RTCA Special Committee 209**ATCRBS / Mode S Transponder MOPS Maintenance****Meeting #14****In Joint Session with EUROCAE WG-49****Host: Rockwell Collins, Inc.****Melbourne, Florida****24 – 28 January 2011****Proposal for the Correction of****BDS Register SWAP Issues****Revision 1****Robert H. “Bob” Saffell****Rockwell Collins, Inc.**

The primary purpose of this document is to present proposed changes to correct BDS Register Swap issues as discussed in the abstract provided on the cover page.

6.a. In section 2.2.19.1.12, change Figure 2-20 to the following:

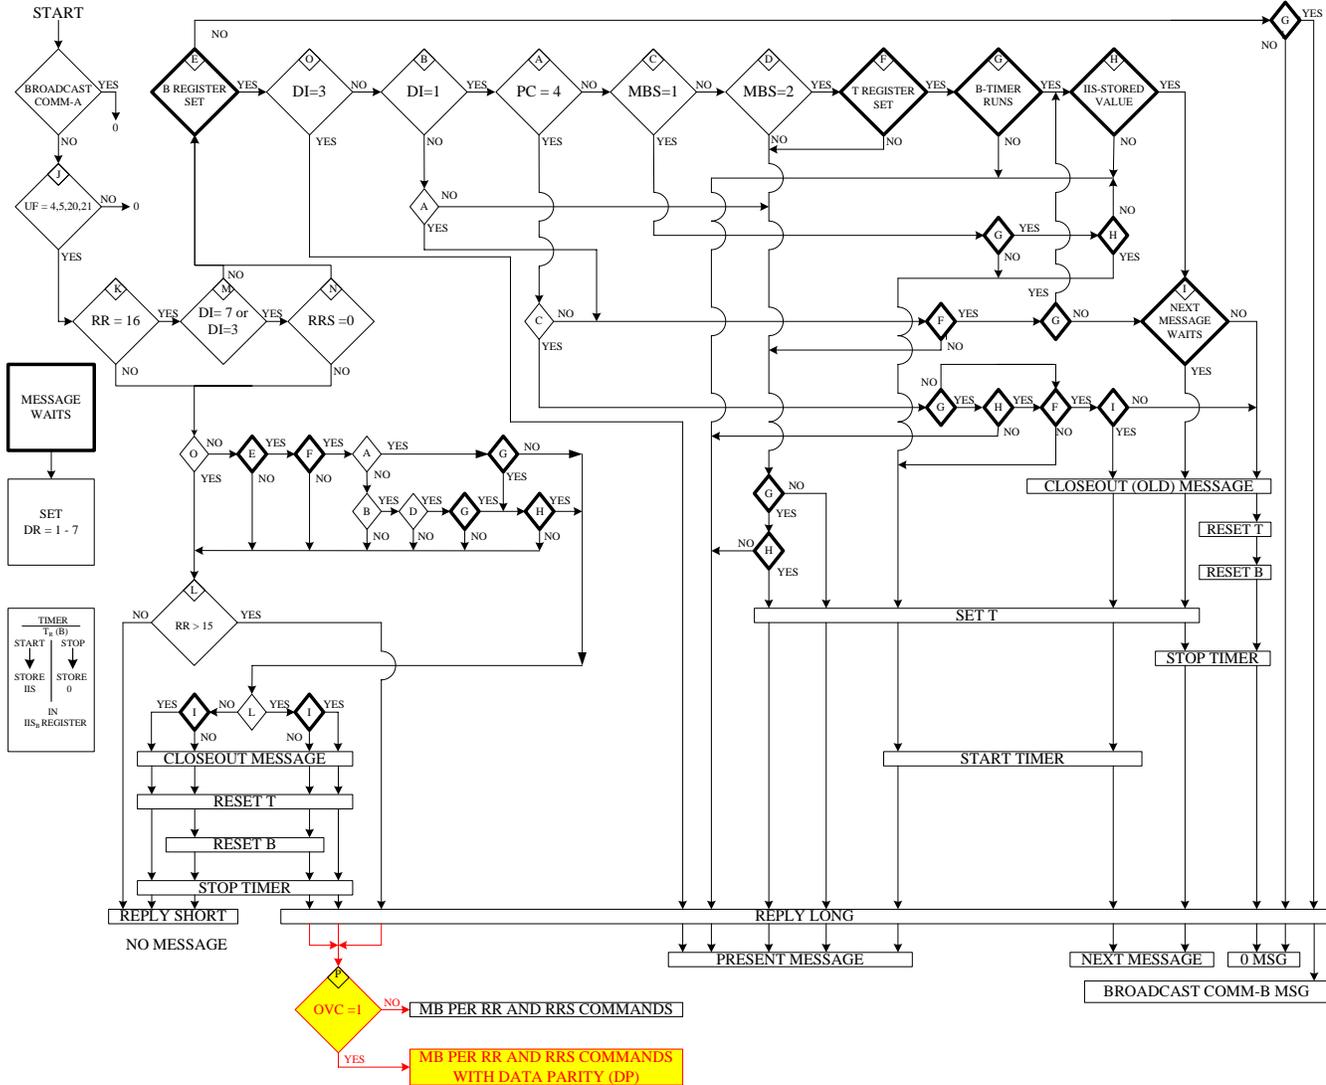
12. Decision diamond "P" applies to transponders supporting the Overlay Command Capability. Otherwise, MB per RR and RRS commands apply.

Make the same changes to Figure 2-25 that were made to Figure 2-20 in Paragraph 6.a of this document.
